Re: Freeport-McMoRan Chino Mines Company –
Permit GR009RE Technical Comments on
Revision Application 18-1 for the Updated Closure Closeout Plan

Freeport-McMoRan Chino Mines Company (Cobre) submitted an update to Chino's Closure Closeout Plan (CCP) on February 14, 2018. The Mining and Minerals Department (MMD) in a letter dated June 18, 2018 requested Chino to respond to agency and public review comments. Where the comments included multiple questions within a paragraph, and in the hope that the response will be easier to track, the response is often located directly below the comment. The comments are listed in italics, followed by Chino's responses.

Figure 2B
Mine Maintenance Facilities Area

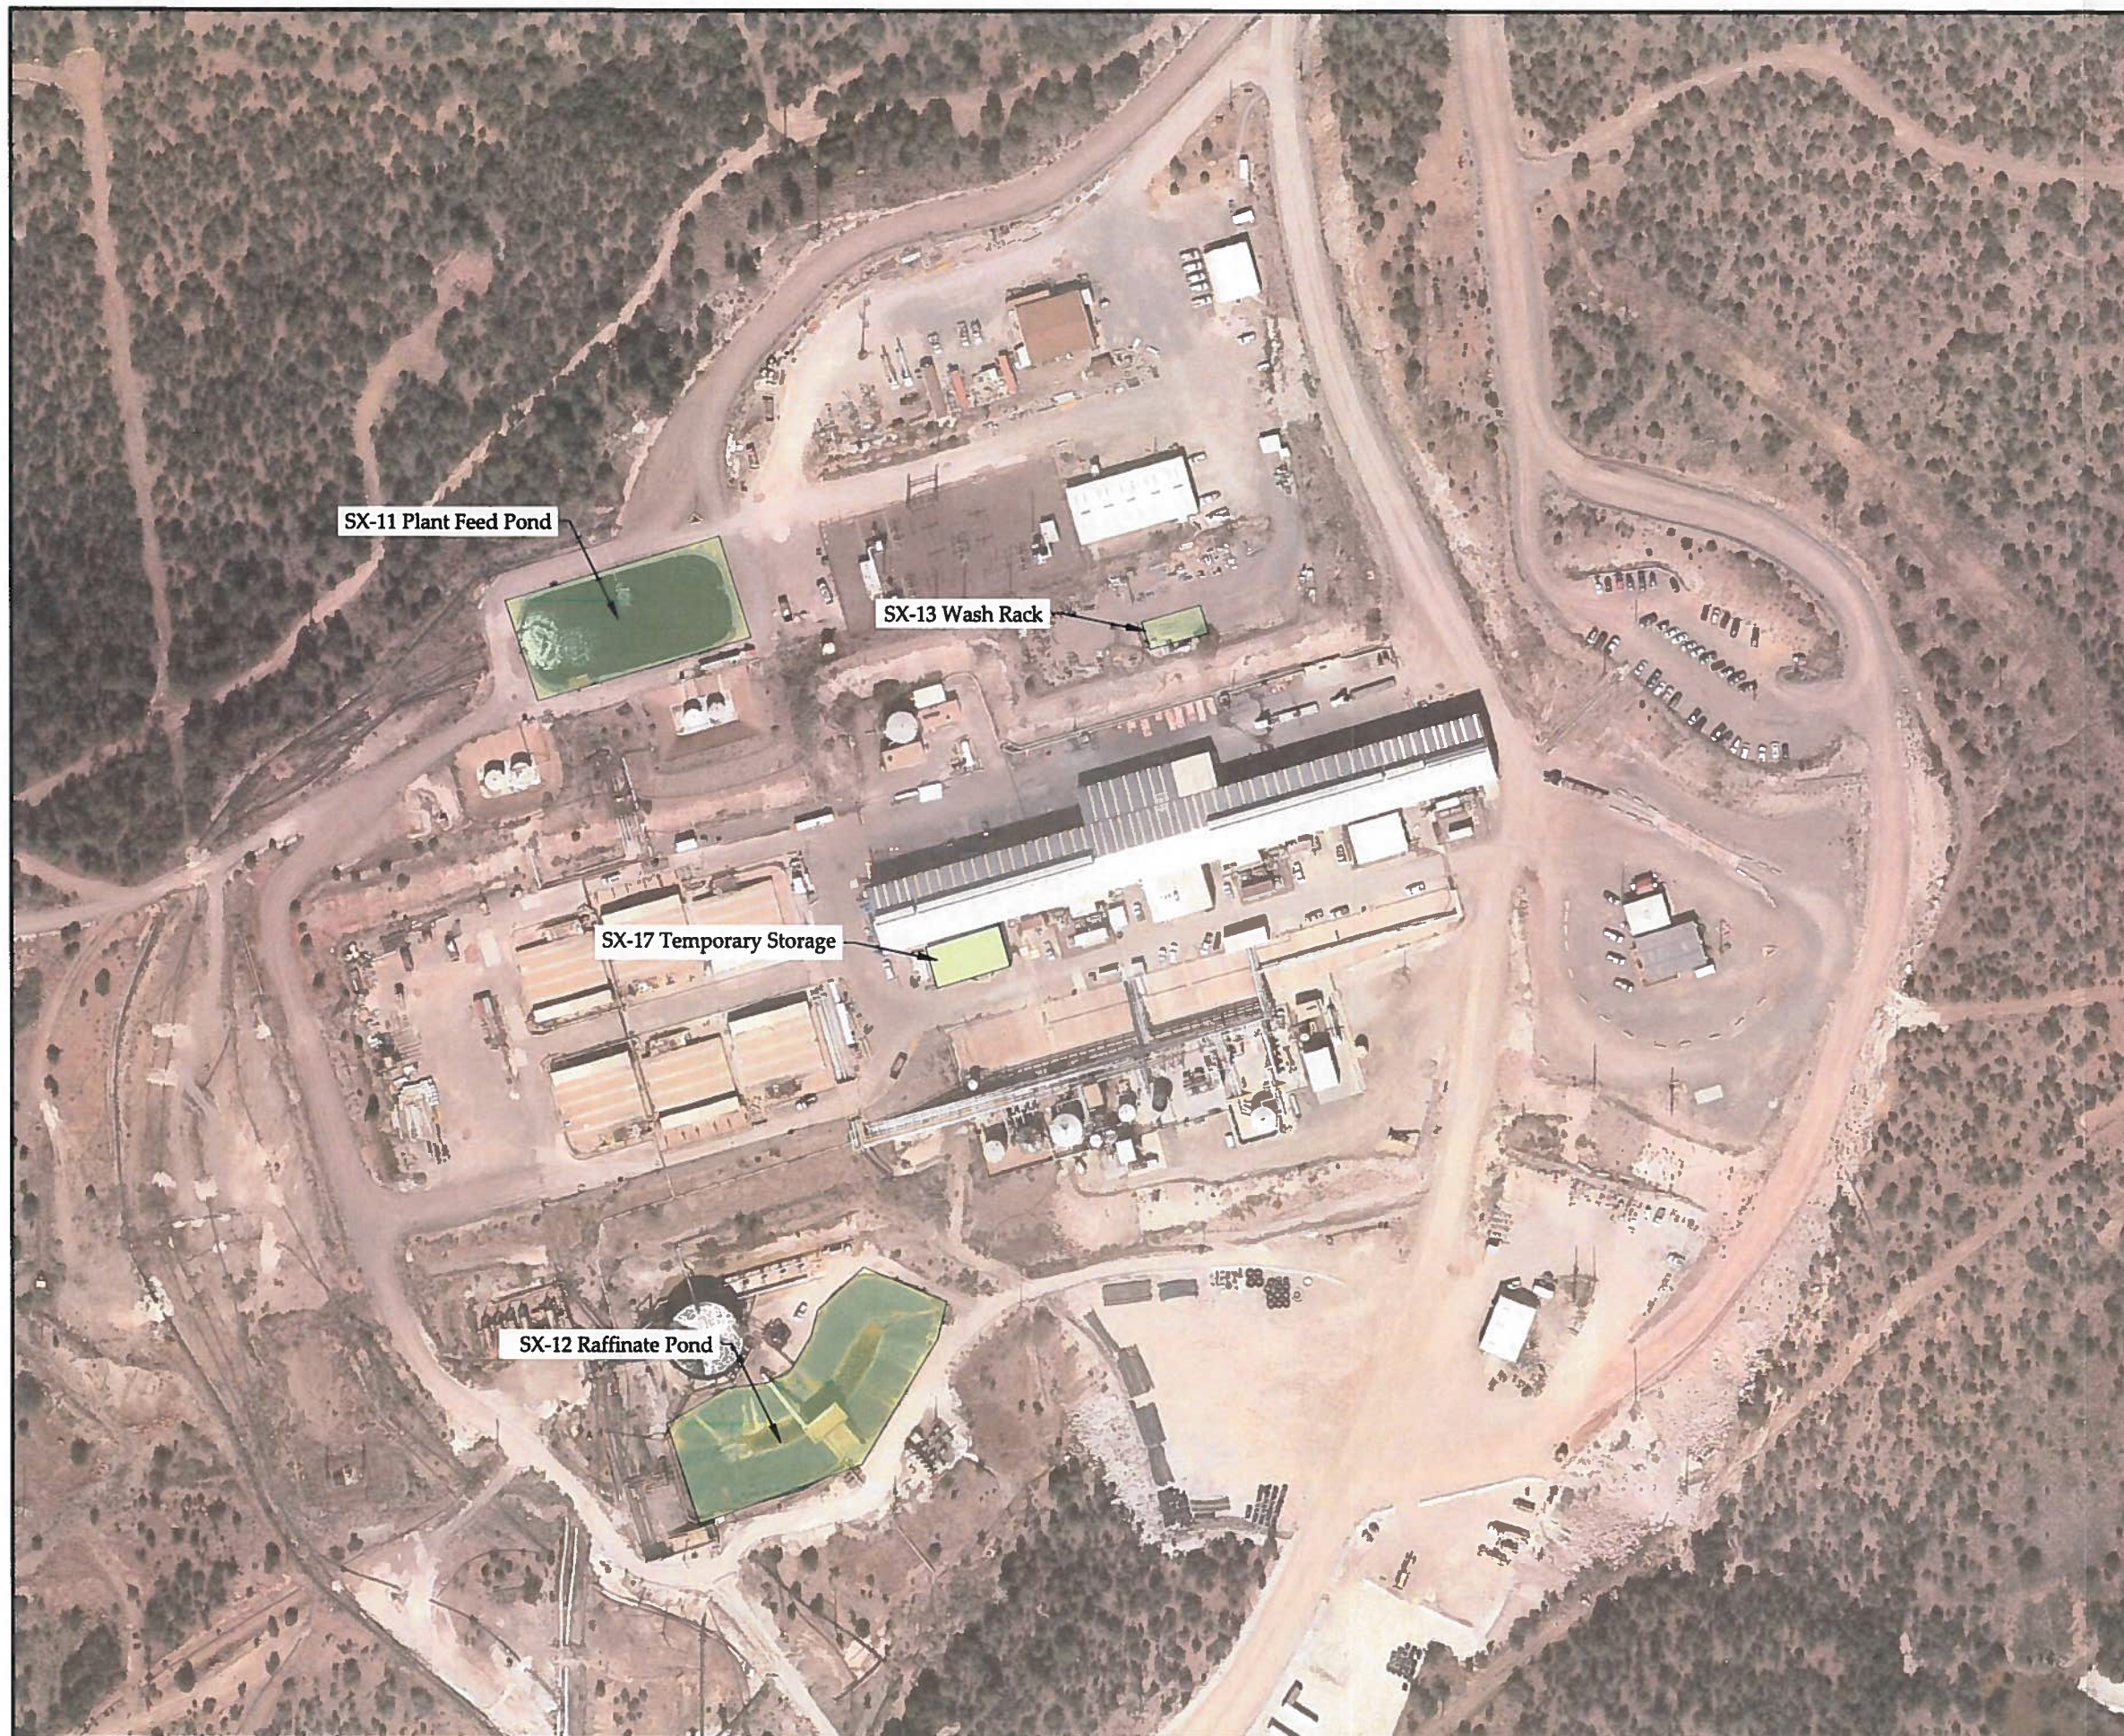
11. *Table 5-2 provides a summary of buildings and structures to be removed/reclaimed. Please provide a map/figure identifying the buildings listed in Table 5-2.*

Chino has developed a new Figure 2 which is now labelled Figure 2A, 2B and 2C that shows the locations of the buildings listed in Table 5-2 and is attached to this response letter.

TITLE
**PROPOSED STS WATER TREATMENT SYSTEM
 AND SLUDGE DISPOSAL FACILITY LOCATION**

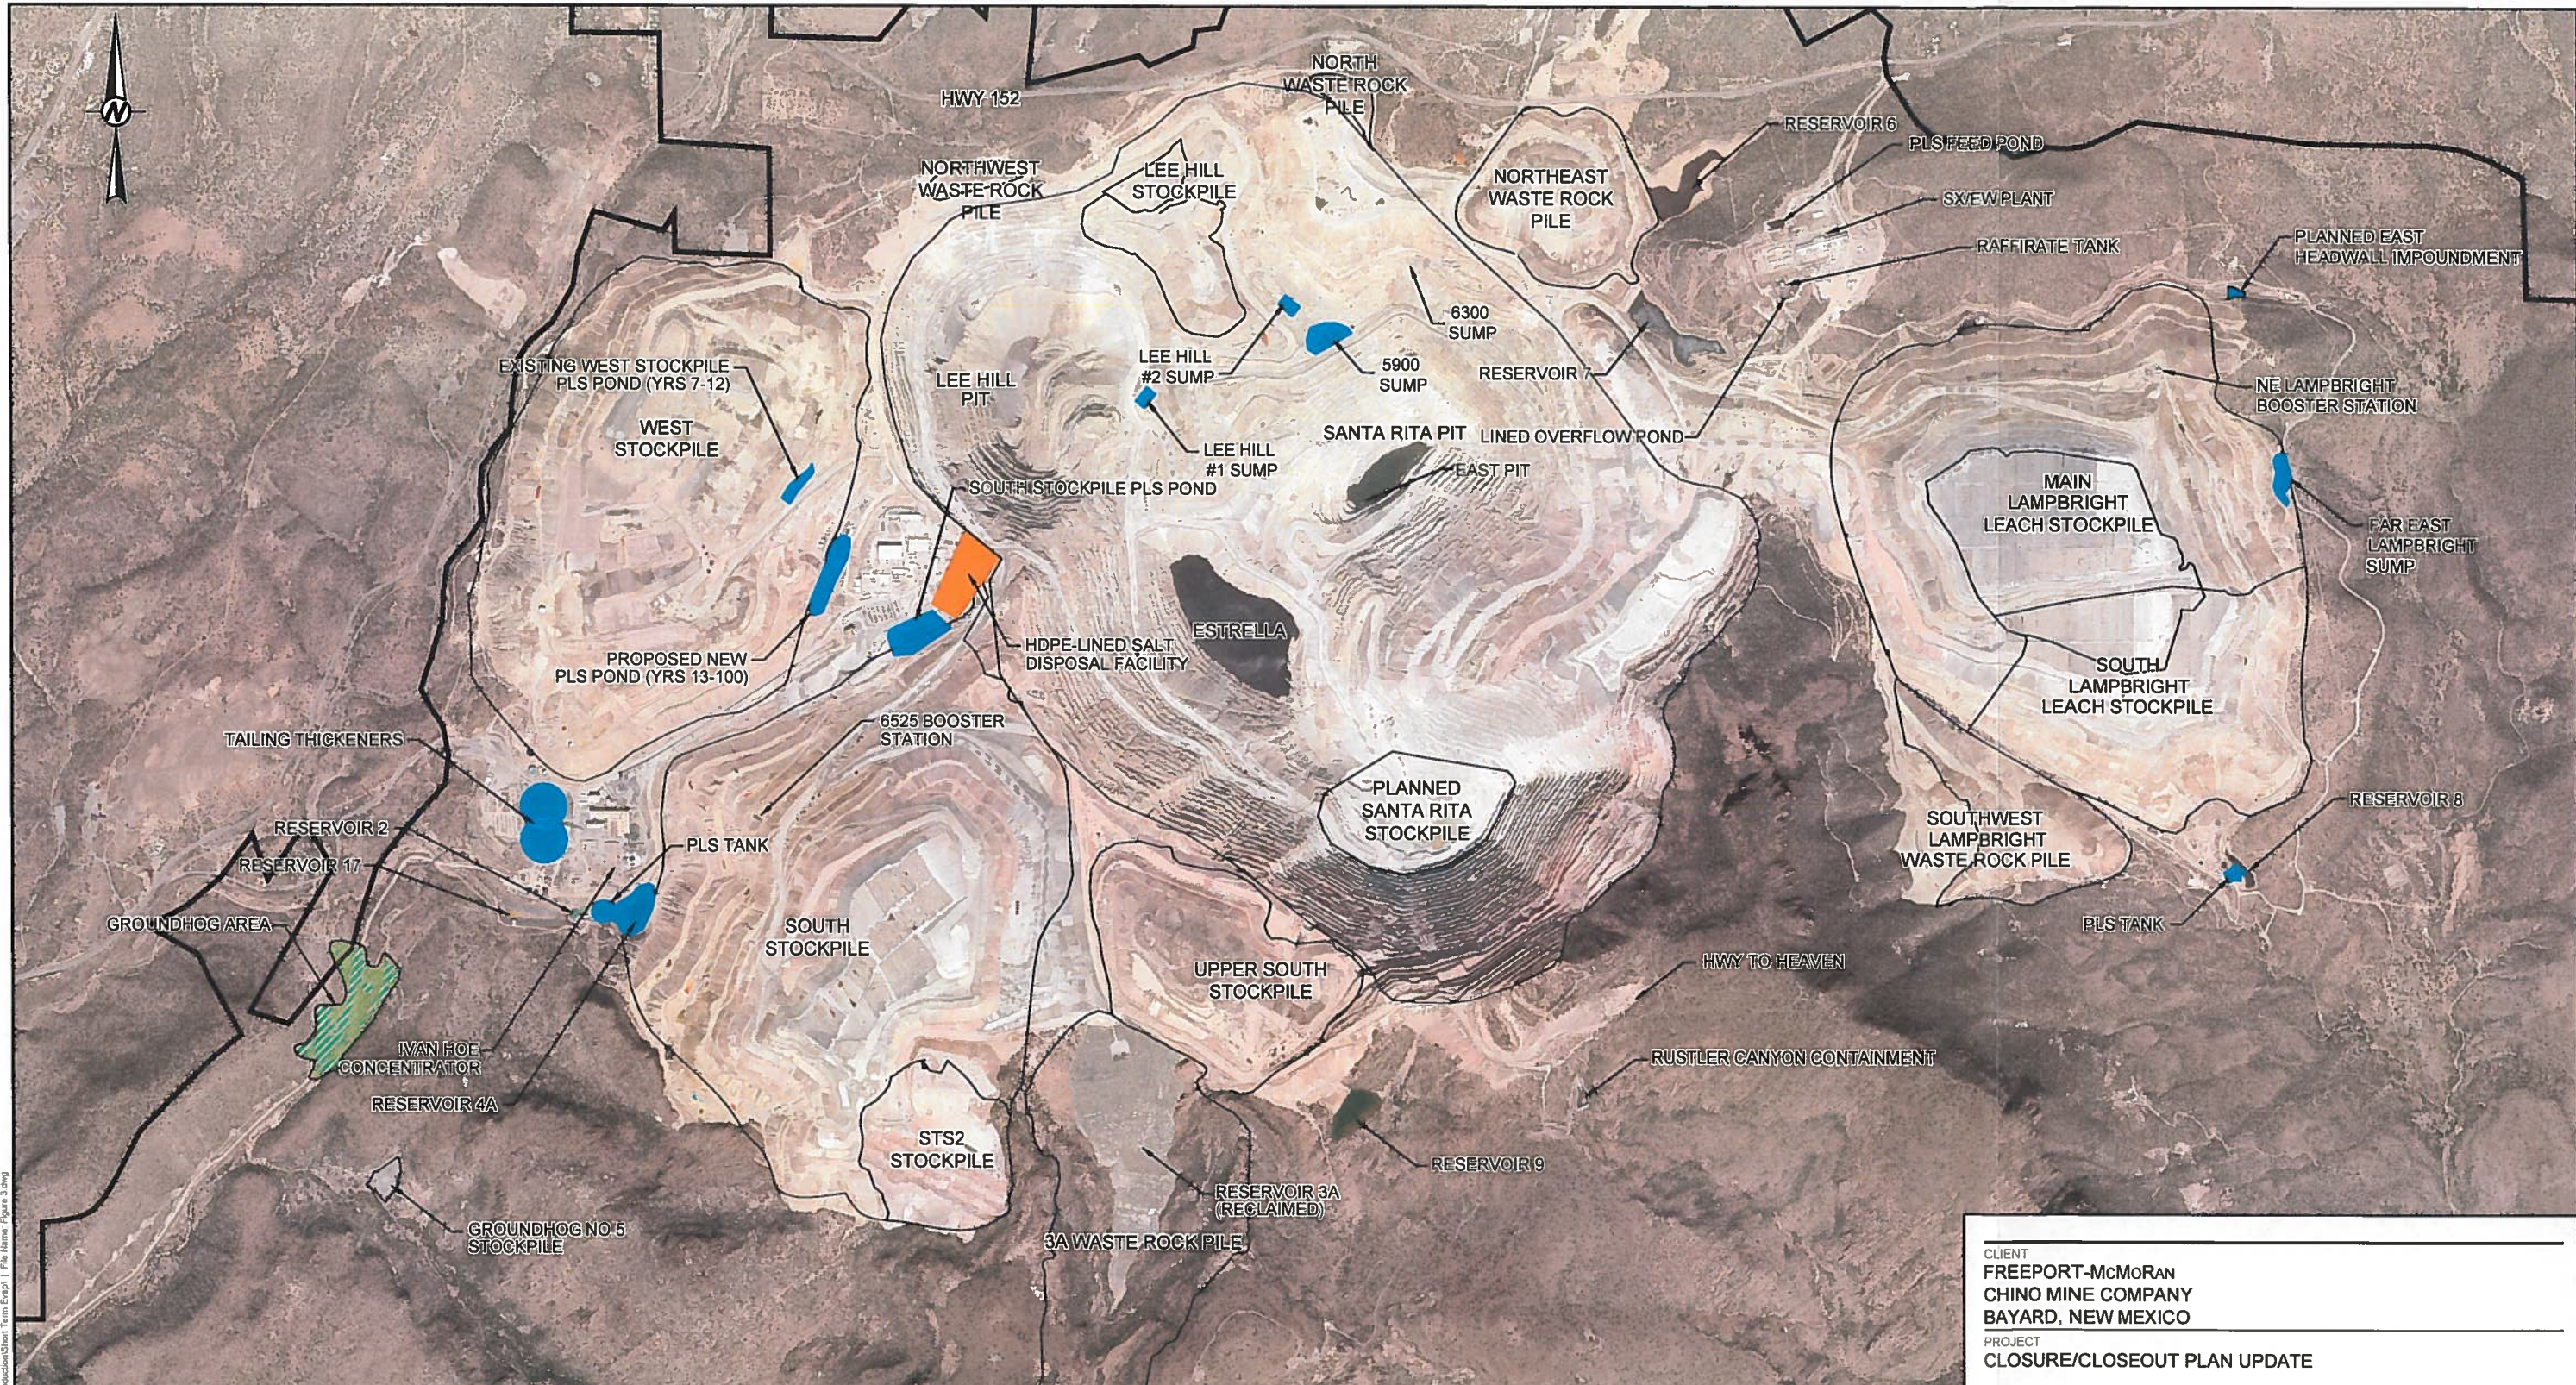
18. *Appendix C Water Treatment, Page 8, Section 2.3; Page 10, Section 3.2; and Table 6 of Attachment A - ETS memo. Chino proposes sludge and salt disposal associated with water treatment. In order to more accurately assess capital costs for the financial assurance proposal, Chino should provide some additional detail with the understanding that some aspects may change at the actual time of construction:*
- *proposed location of water treatment facilities*
 - *proposed location of SDF & dimensions of lined pond*
 - *proposed location of salt disposal facility & dimension of lined pond, and*
 - *provide map(s) that show specific locations for treatment and disposal.*

The locations of the proposed sludge disposal facility and the STS water treatment facility are shown on new Figure 3 to Appendix C. The proposed sludge disposal facility will cover an area of approximately 30 acres on the unreclaimed portion of Pond 6E, and the STS treatment facility will be located nearby on the unreclaimed portion of Pond 6W. New Figure 3 is attached to this response letter. The location of the proposed salt disposal facility has been added to Figure 3 of Attachment A to Appendix C and is also attached to this response letter. The proposed salt disposal facility will cover approximately 10 acres on the east side of the Mine Maintenance Facilities Area.
